**SUBJECT: BERM ADJACENT GAGLARDI WAY - RESIDENT PROPOSAL**

**PURPOSE:** To respond to correspondence to Council regarding a proposal by residents to construct a 500 foot long noise attenuation berm adjacent the east side of Gaglardi Way north of Eastlake

BERM PROPOSED BY RESIDENT  
NE of GAGLARDI / EASTLAKE

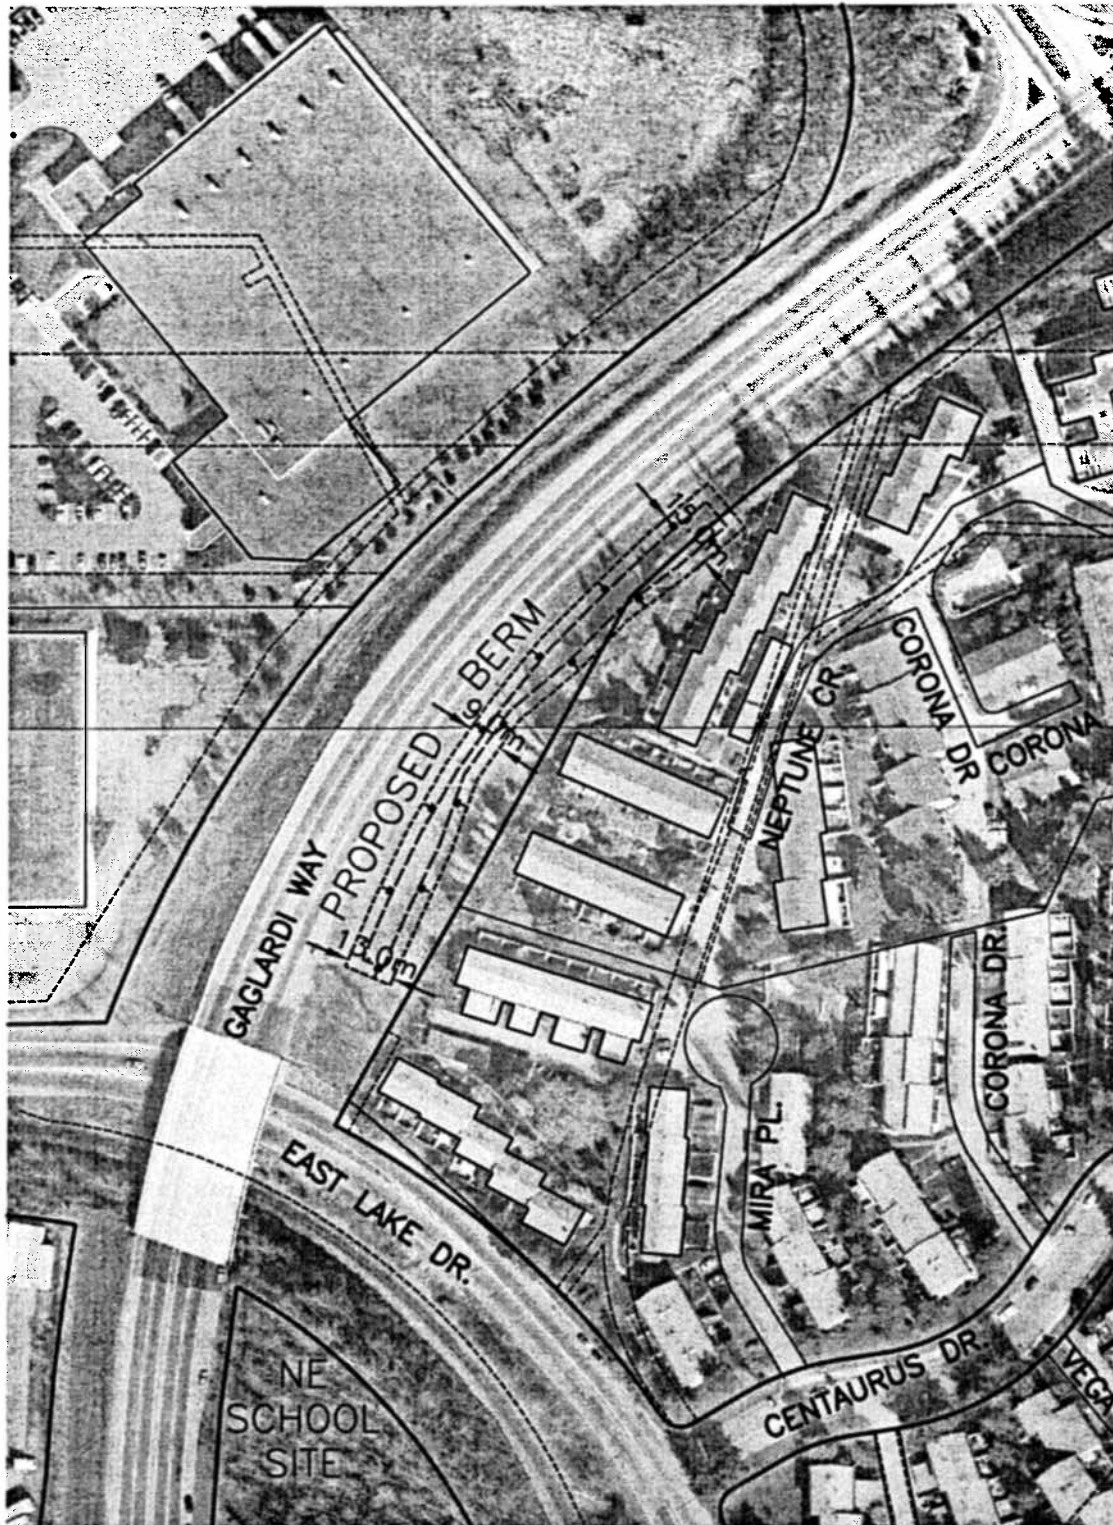
The residents proposed constructing the berm on the Gaglardi Way right-of-way more or less as shown on the attached sketch. Their intent was to utilize the flared width in the right-of-way that extends to the overpass of Eastlake. While the right-of-way width is generous enough to accommodate some future widening of the roadway it is also needed for the highway drainage. The right-of-way flare reflects the embankment required for Gaglardi to bridge over Eastlake. Accordingly, the length and height of a feasible berm that could be developed is less than the 500 feet length and 11 - 12 foot height estimated in the resident proposal. The length and continuity of the berm is a significant factor in its effectiveness as discussed below.

While at first blush it may appear that constructing a berm is as simple as piling up free fill and grading it, this is not the case. It is a structure that would need to be properly designed and finished. Geotechnical and environmental issues would need to be addressed prior to design and the quality and placement of the fill would need to be monitored. In this case we would be particularly concerned about the highway runoff, which is currently intercepted and directed to Stoney Creek.

Were the berm proposed feasible it would be suboptimal in its location because it lies between noise source (the highway) and receiver (residents) and is not continuous. Ideally, sound attenuating barriers along roads should be as close to the noise source or the recipient as possible and extend longitudinally well beyond the residential area protected. In this case the location of a barrier berm is also compromised by the terrain; with the road being higher than the residential development most if not all of the berm height would not provide any attenuation of sound. The limited length over which a berm of the requisite height might be developed limits any potential benefit of the berm to a small proportion of the multifamily units adjacent Gaglardi in NW97.

Given Council Policy and the significant drawbacks to the berm proposal staff suggested that the residents of NW97 individually or as a strata should focus on “receiver side” measures to mitigate highway noise. We noted that “this could include double glazing windows to minimize interior noise and “enclosing” outdoor activity areas such as patio seating with fencing. Although there is some question as to how effective vegetation can be in blocking noise, the potential screening effect of evergreen planting on your property should also be considered.”
